Re: FERC project #P-14308-001—VT  
Vermont Tissue Mill Dam Hydroelectric Project  
Carbon Zero, LLC

*Re: Vermont Tissue Project-FERC# P-14308-001*  
*1. Amendment to prescribed bypass flows*

## VT Tissue Hydro – Secondary Channel Flow Assessment and Report

Flow 1

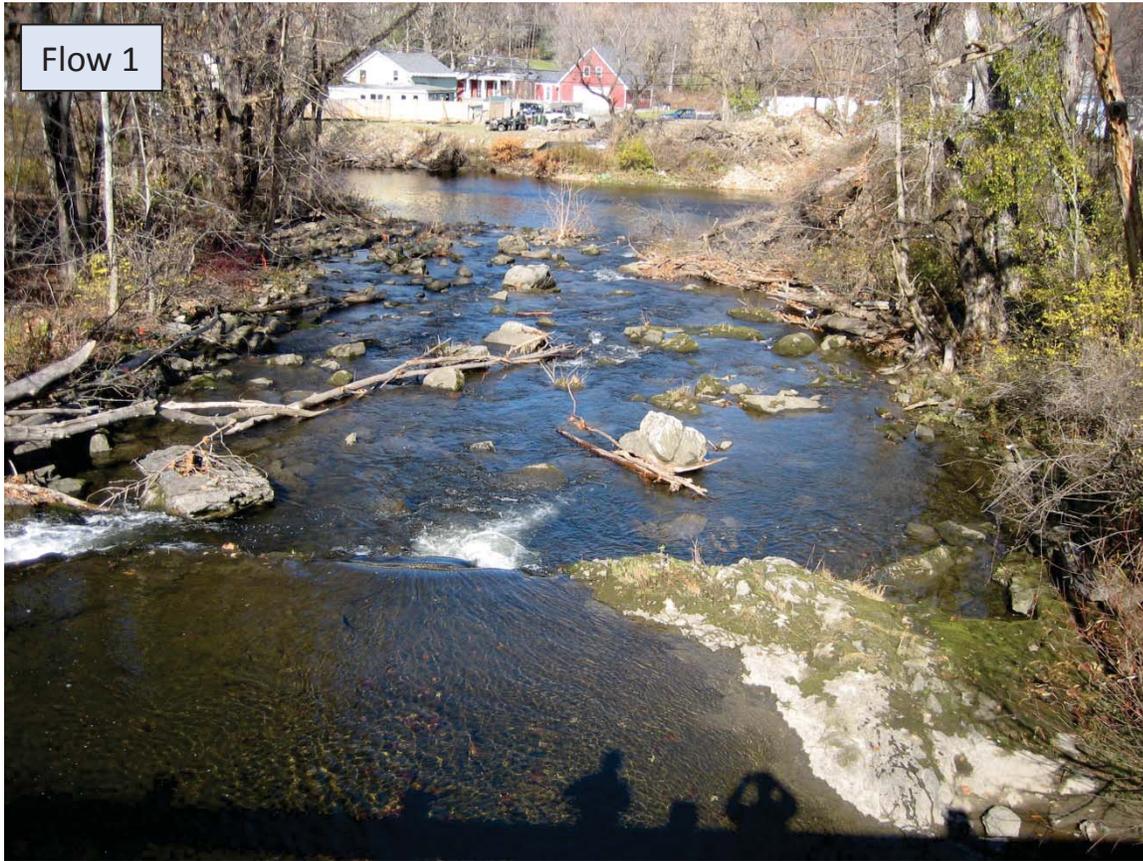
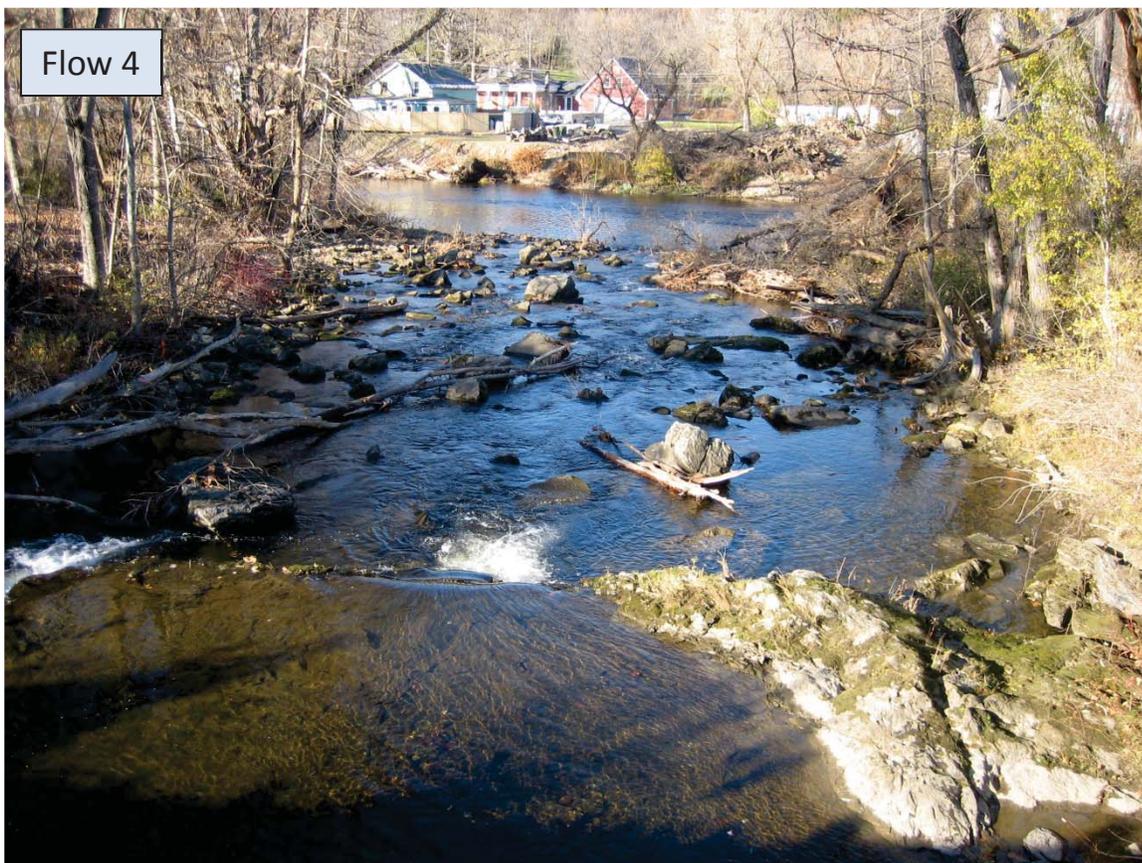
Water depths in the bypass decreased with each successive flow assessed. In comparing the Flow #1 and Flow #5 photos, the bypass is shrinking to shrinking. A rocky area near the confluence with the main channel (left side) is essentially dewatered at Flow #5, and an area between the two transects (right side) was reduced to a depth of about two inches. This area showed a noticeable decrease in depth beginning with Flow #3.

In summary, Flows #1 and #2 looked very good. Both Flow #3 and #4 looked good; Flow #4 was shallower but still met the assessment criteria. Flow #5 exhibited several unacceptable conditions as described. The flow requirement for the secondary bypass channel can be revised to 15 cfs.
